**MODIFICATION INSTRUCTION**

Bulletin Nbr: 248-2245

**Incorrect position, rear oxygen sensor cable US**

Saab 9-3 Viggen M99 with VIN X7020001 - X7063257

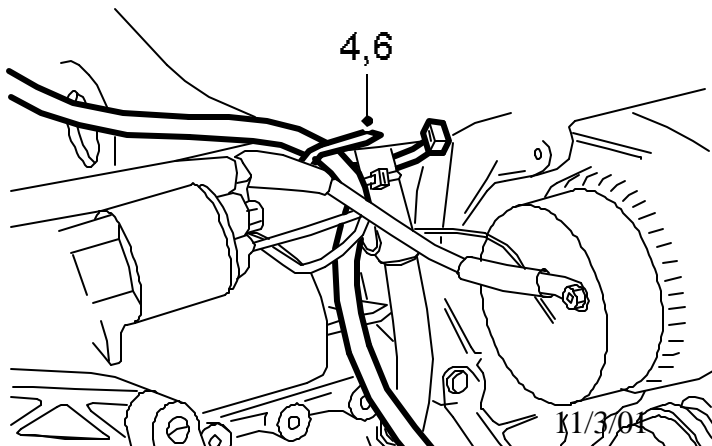
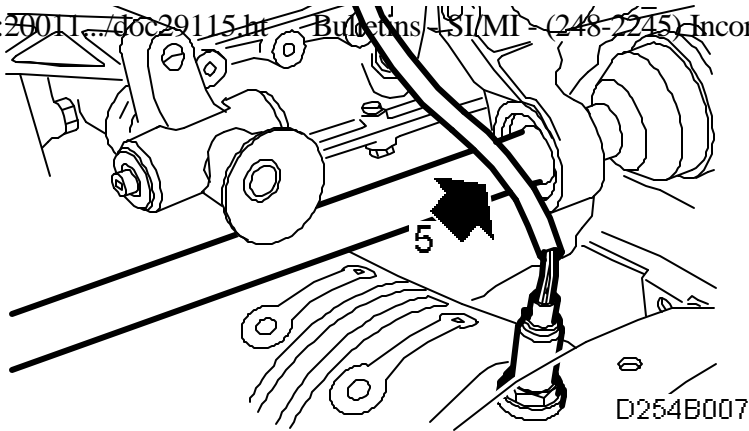
The rear oxygen sensor cable on certain cars may be lying too close to the intermediate shaft, which means that the cable sheath and insulation can be damaged. This is caused by the cable being poorly secured.

1. Check the oxygen sensor cable in the illustrated area
2. If only the outer sheath of the oxygen sensor cable is chafed, it will suffice to insulate the damaged area with insulating tape. Continue to step 4.
3. If the cable has been damaged down to the insulation then the oxygen sensor must be replaced. See WIS - Engine - Trionic T7 OBD2 - Adjustment/replacement - Rear oxygen sensor. Do not forget to secure the cable with the cable tie as described in steps 5-7.
4. Cut off the cable tie securing the rear oxygen sensor cable to the oil filler pipe.
5. Run the cable so it is not resting against the intermediate shaft. It must not be taut either
6. Secure the cable to the oil filler pipe with a new cable tie.
7. Cut off the loose end of the cable tie.
